**ADDENDUM #1
Board of County Commissioners
Murray Street Parking Lot Proposal
BID # 7167-20**

September 10, 2020

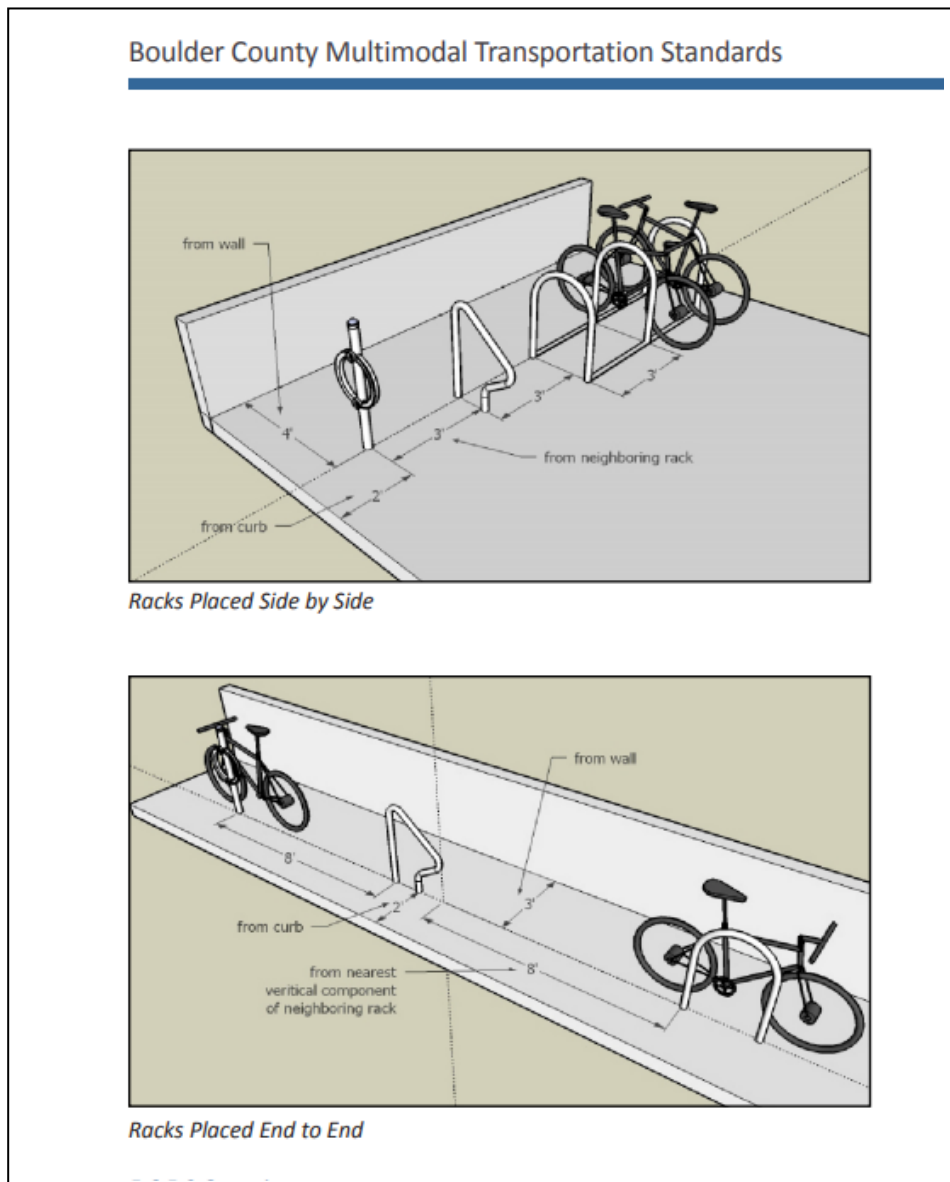
16. Question: Please provide a bike rack specification and mounting detail.

**ANSWER: Boulder County Multimodal Transportation Standards state:
Section 5.6.5 - Bicycle Parking**

This section outlines the type, placement, and quantity of bicycle racks to be provided to ensure the safety, convenience, and availability of bicycle parking facilities in appropriate areas of Boulder County.

5.6.5.1 Rack Types - The "Inverted U" style bicycle rack is recommended. See drawing below for mounting dimensions.
